VILLAGE OF MORTON GROVE APPEARANCE COMMISSION

June 6, 2022 - 7:00 P.M. AGENDA

CASE AC 22-04

Re: <u>Appearance Commission Case AC 22-04</u>

Select Areas Requiring Screening (Yellow)

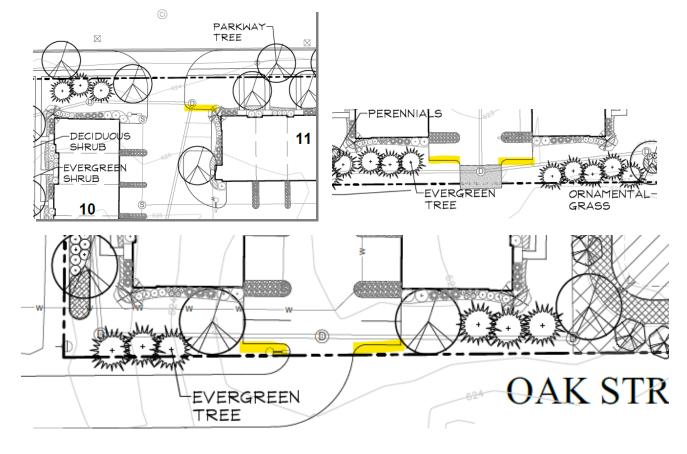
The applicant is proposing significantly fewer trees than required within the public rights of way abutting the development site. Along Lehigh Avenue, 12 trees are required to be planted and zero trees are proposed. The developer should explain the reason for the lack of tree plantings. If insufficient space is available to support healthy tree growth, the Appearance Commission may recommend that additional trees are planted near the public right of way line. Staff notes that 15 trees are already proposed within the open space area at the property's northeast corner and along the Lehigh Avenue lot line. This may be deemed sufficient by the Appearance Commission.

In select areas, required screening has not been provided for parking areas that are adjacent to private property and public rights of way. Examples of such areas are shown in the images that follow. Staff recommends that the landscape plan is modified to meet Code requirements, or the Appearance Commission may grant waivers to authorize the landscape plan as presented.
